FIG. 23

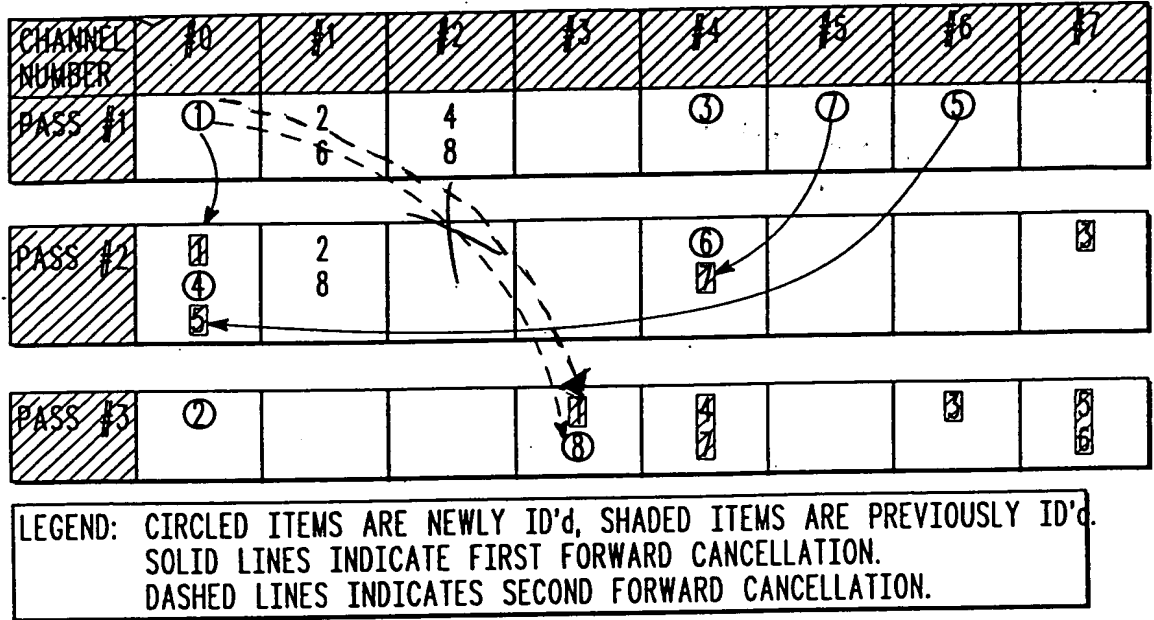
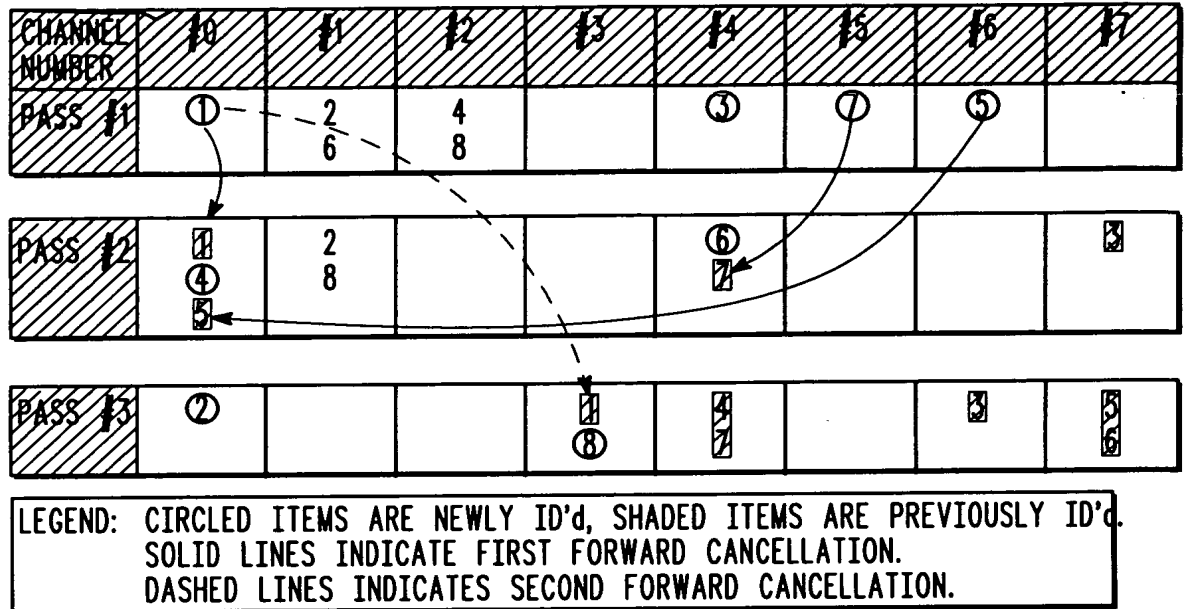
Please amend FIG. 23 by replacing the dotted line from the circled item 1 in pass #1 with the arrowhead pointing to the circled item 8 in pass #3, with a dotted line from the circled item 1 in pass #1 with the arrowhead pointing to the boxed item 1 in pass #3, as shown in red on the attached copy.

FIG. 24

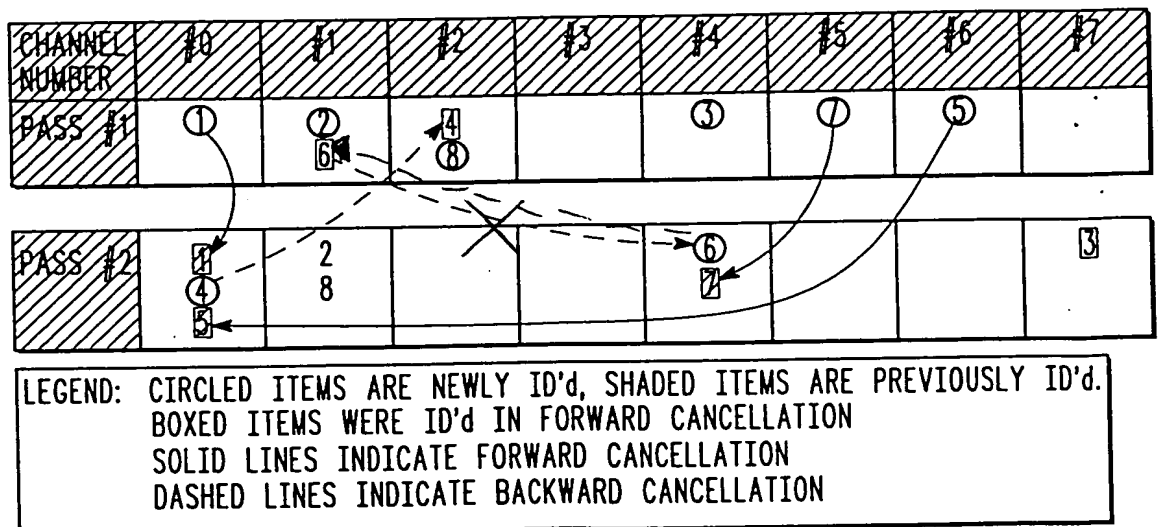
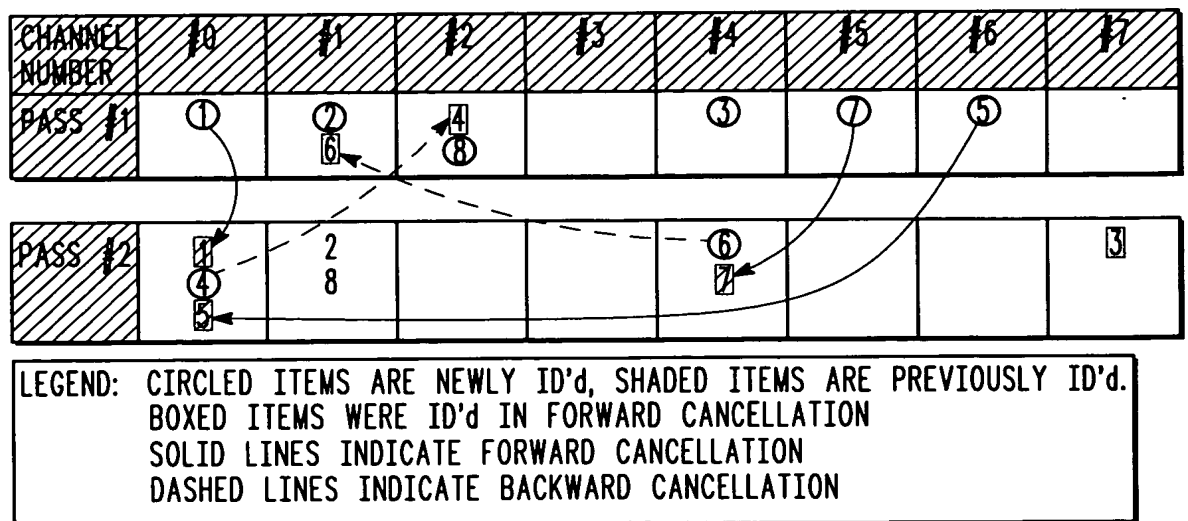
Please amend FIG. 24 by replacing the dotted line from the boxed item 6 in pass #1 with the arrowhead pointing to the circled item 6 in pass #2, with a dotted line from the circled item 6 in pass #2 with the arrowhead pointing to the boxed item 6 in pass #1, as shown in red on the attached copy.
